↳ Respond to BUILDING DEPARTMENT COMMENTS.
CHANGES TO PLANS OR DETAILS BROUGHT ABOUT DO TO
REVIEW ARE SHOWN CIRCLED WITHIN.

LANIER - PFEESER

019-124

MAIN FLOOR FRAMING PLAN
SHEAR WALLS BTW LOWER / MAIN FLOOR
 LOWER LEVEL ARCHITECTURAL PLAN
 PROJ. 019-124

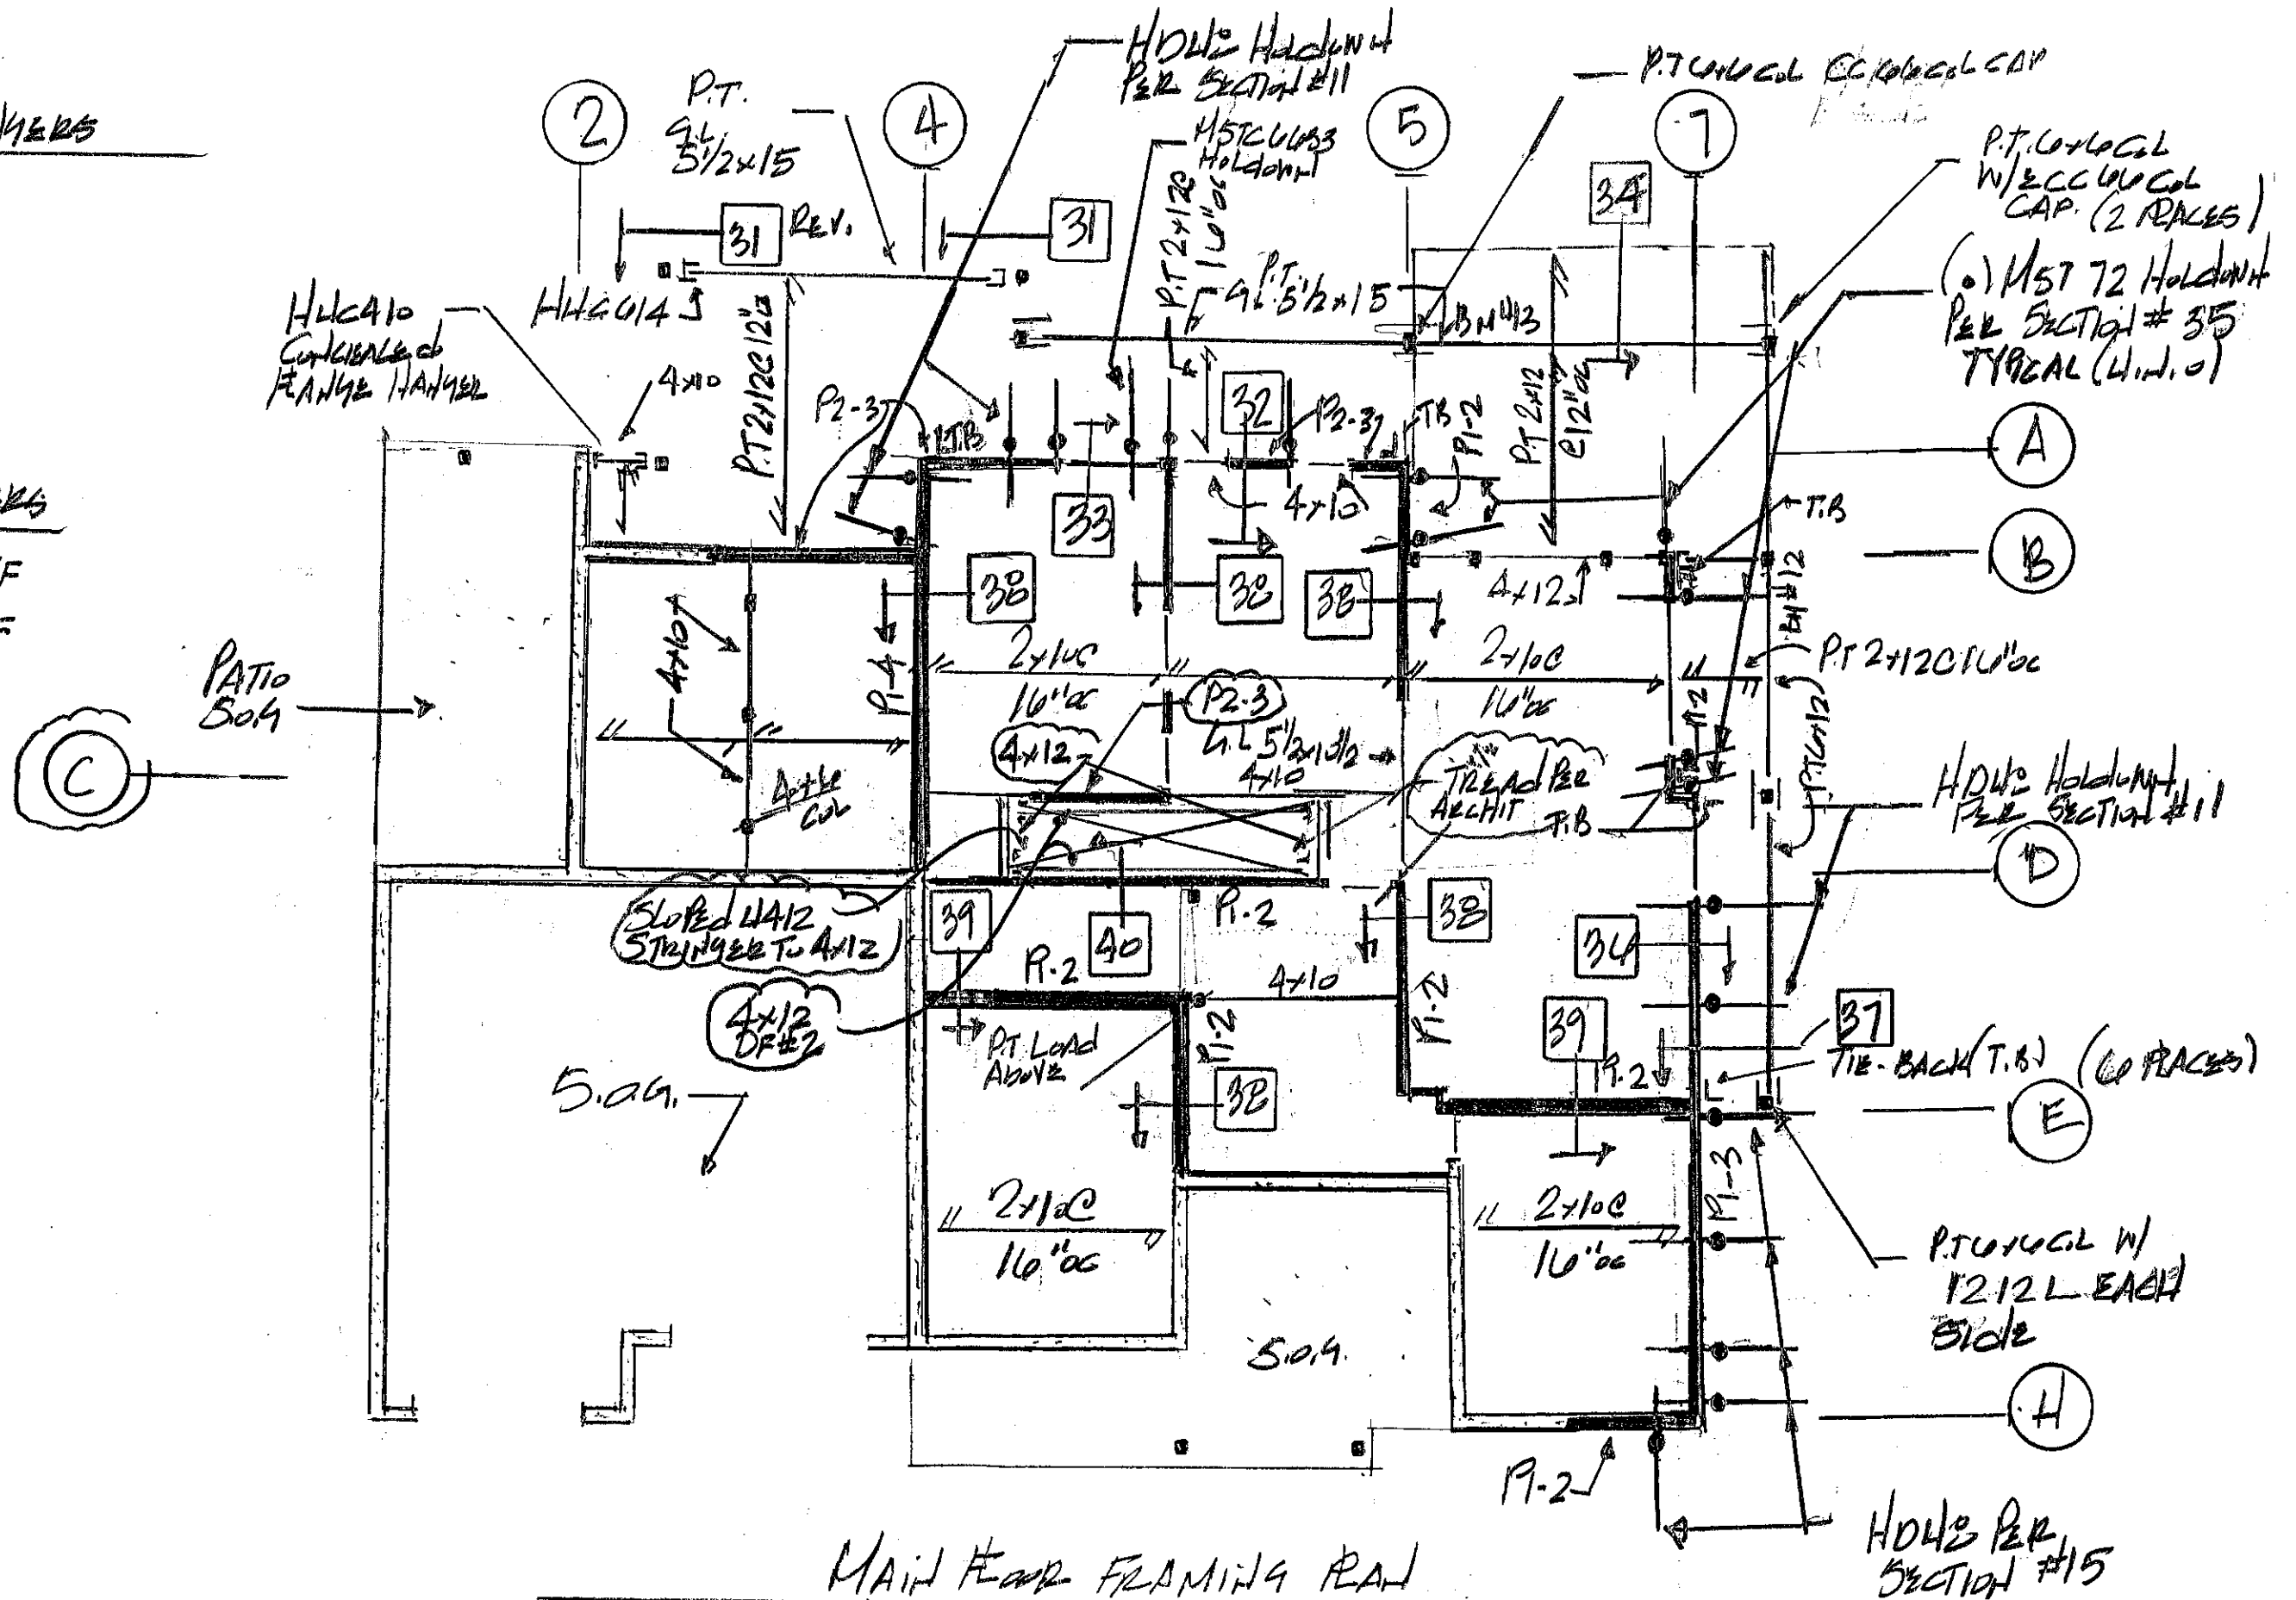
COMMENT #3:

COMMENT #4:

COMMENT #5:

COMMENT #6

COMMENT #7

COMMENT #8

COMMENT #9:

COMMENT #10

COMMENT #11:

COMMENT #12

↳ USE WALL @ GRID (C)
√ → 200 PF + 19' = 3910' / 0.5' = 002 - P2.3
1.3910' / 0' = 0510' - ADD HOLD

↳ SAME COMMENT AS #3 ABOVE

WALLS USED IN THE DESIGN HAVE A HOLDDOWN
ON EACH END THE OTHER WALLS ARE REDUNDANT
WALLS NOT USED IN THE DESIGN.

#6 INSTALL COILED STRAP ON TOP OF REINFORCED AS COLLECTOR
THE (2) SHORT WALLS ARE REDUNDANT WALL NOT USED
IN THE DESIGN

While specified as P-2 SHEAR WALL IT WAS NOT USED IN DESIGN. - No Holddown Req'd

Add Holddowns ON SHEET A3 WITHIN

WALL NOT USED IN THE DESIGN ∴ Holddown NOT Required

While specified as P-2 SHEAR WALL IT WAS NOT USED IN THE DESIGN ∴ No Holddown Req'd

While specified as P-2 SHEAR WALLS THEY WERE NOT USED IN THE DESIGN ∴ No Holddown Req'd

(3) WALLS WERE NOT USED IN THE DESIGN
 $3000 \times 9.5 / 13 = 2190$

$M = 2190 \times 3.5 = 7405 \times 12 / 2400 = 3212 \text{ in}^3 \leq 6091 \text{ in}^3$

∴ 5/20/19 - OK
